SUBJECT: NEW VEHICLE DEMONSTRATION / DELIVERY HOLD
Customer Satisfaction Program 20B14 – Supplement #1
Certain 2020 Model Year Escape Full Hybrid Electric Vehicle
Powertrain Control Module Update

New! REASON FOR THIS SUPPLEMENT

- *Updated Technical Information with revised programming procedures.*

CERTAIN 2020 MODEL YEAR ESCAPE FULL HYBRID ELECTRIC VEHICLE — POWERTRAIN CONTROL MODULE REPROGRAM

FIGURE 1

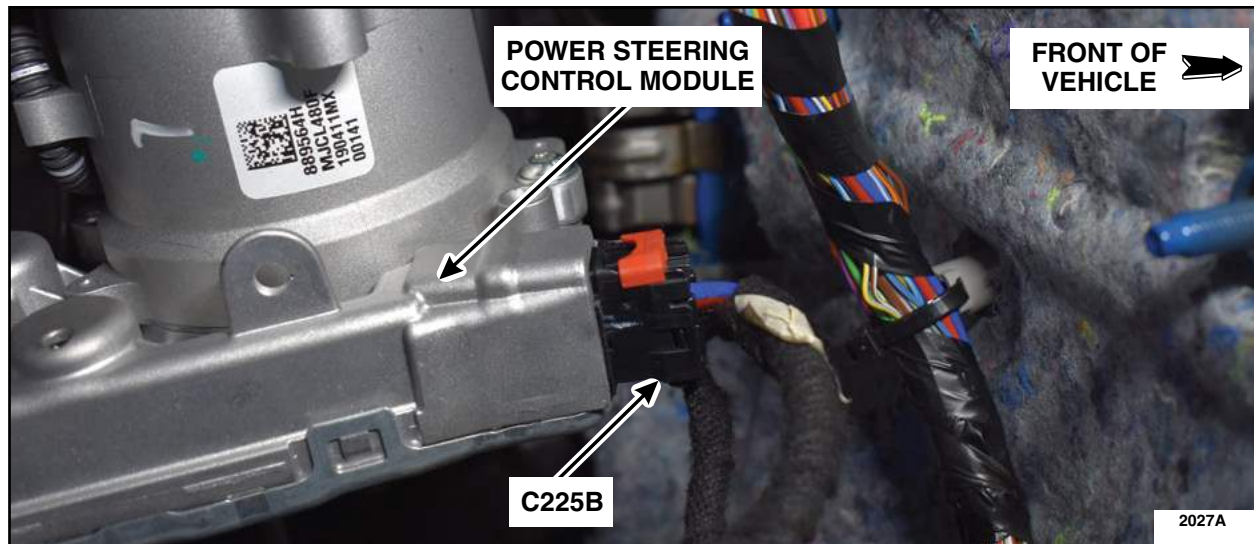
1. Disconnect C225B at the Power Steering Control Module (PSCM) prior to installing the battery charger. To disconnect C225B pull back on the red locking tab, press down on the tang and then pull the connector housing straight out. C225B will remain unplugged during the programming procedure. See Figures 1 and 2.

10. Connect and lock the red tab of C225B to the PSCM. See Figures 1 and 2.
